The Horsley Drive upgrade between M7 Motorway and Cowpasture Road

Submissions report

Roads and Maritime Services | December 2018

Prepared by GHD and Roads and Maritime Services

Figure 4-1 Location of the businesses assessed in the BIA (Source: SMEC, 2017 – modified by GHD)

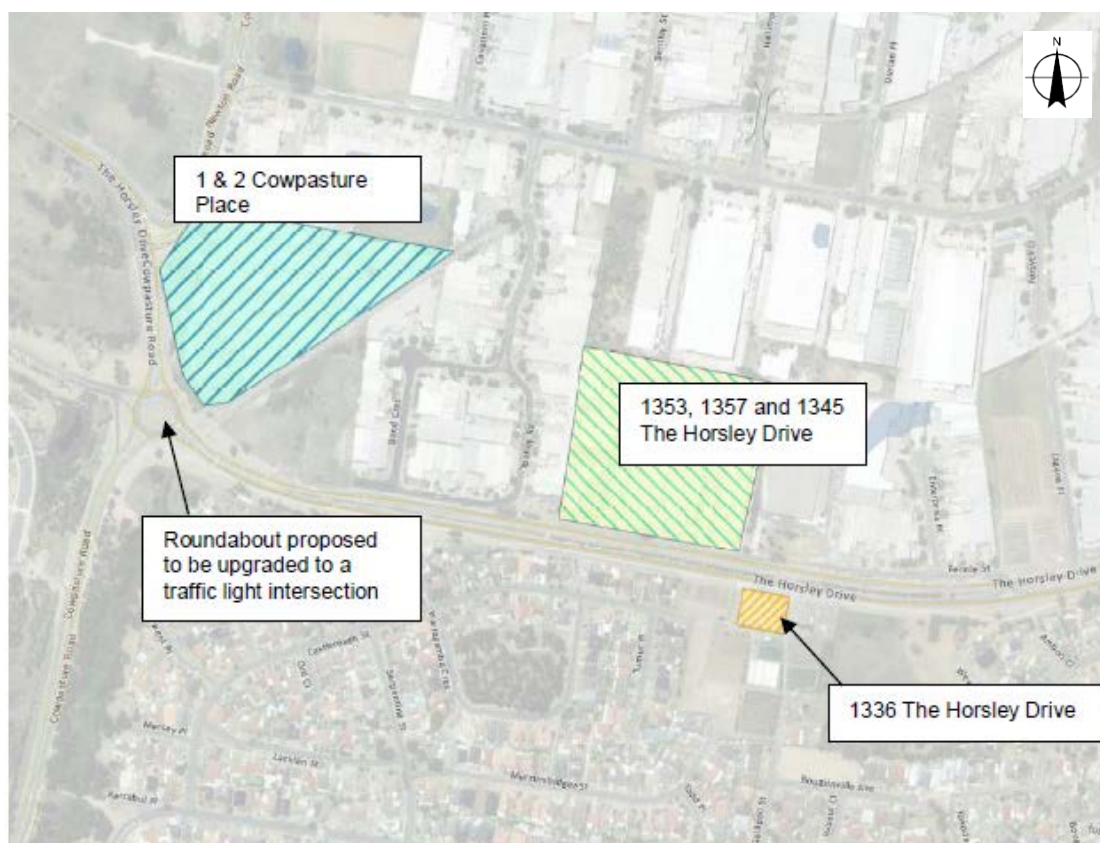
As a response to numerous submissions received regarding the change in traffic conditions and property access as a result of the signalisation of The Horsley Drive/Cowpasture Roads intersection, Roads and Maritime engaged GHD to prepare a Business Impact Assessment (BIA). This assessment aimed to understand the potential impacts to businesses located at three sites to the east of the roundabout at The Horsley Drive and Cowpasture Road.

The locations of these sites are shown in Figure 3-1. There are approximately 90 businesses located across these sites.

Businesses located at 1 and 2 Cowpasture Place

The access arrangements for customers and delivery vehicles visiting businesses at this location would not change as a result of the proposal. However, customers and delivery vehicles exiting this site with the intention to travel west on The Horsley Drive or north on Cowpasture Road would be required to take an alternate route as they would no longer be able to make a u-turn at The Horsley Drive/Cowpasture Road roundabout.

Based on the outcomes of the BIA, it is unlikely that the small increase in travel distance for some customers would deter them from visiting these businesses. Given that deliveries are scheduled and correspond to business agreements, it is considered that the delivery vehicles exiting to the west or north are likely to plan their journey ahead to meet their schedules.

Customers and delivery vehicles travelling to businesses at this location from the east would be required to take an alternative route as they would no longer be able to perform a u-turn at The Horsley Drive/Cowpasture Road roundabout. This would mean a potential increase in travel distance of 1.1 kilometres (around 3.7 minutes) or 2.4 kilometres (around four minutes), depending on the chosen alternative. The access arrangements for customers and delivery vehicles traveling from the west along the Horsley Drive or north/south along Cowpasture Road would not change as a result of the proposal. There would also be no change to customers and delivery vehicles exiting the site as a result of the proposal.

The access arrangements for customers and delivery vehicles visiting this business would not change as a result of the proposal. However, customers and delivery vehicles exiting this site with the intention to travel east along The Horsley Drive would be required to take an alternate route as they would no longer be able to make a u-turn at The Horsley Drive/Cowpasture Road roundabout. This would result in a potential increase in travel distance of up to 2.4 kilometres or four minutes. The existing arrangements for customers exiting the site to other directions, such as west on The Horsley Drive or north/south on Cowpasture Road, is not expected to change as a result of the proposal.

Based on the outcomes of the business impact assessment, given the type of specialist products and services offered at the business (nursery and farming) and that it receives some appointments, it is likely that customers would plan ahead to intentionally visit the business. It is unlikely that the potential increase in travel distance when exiting the site to some of the customers would deter them from visiting the business.
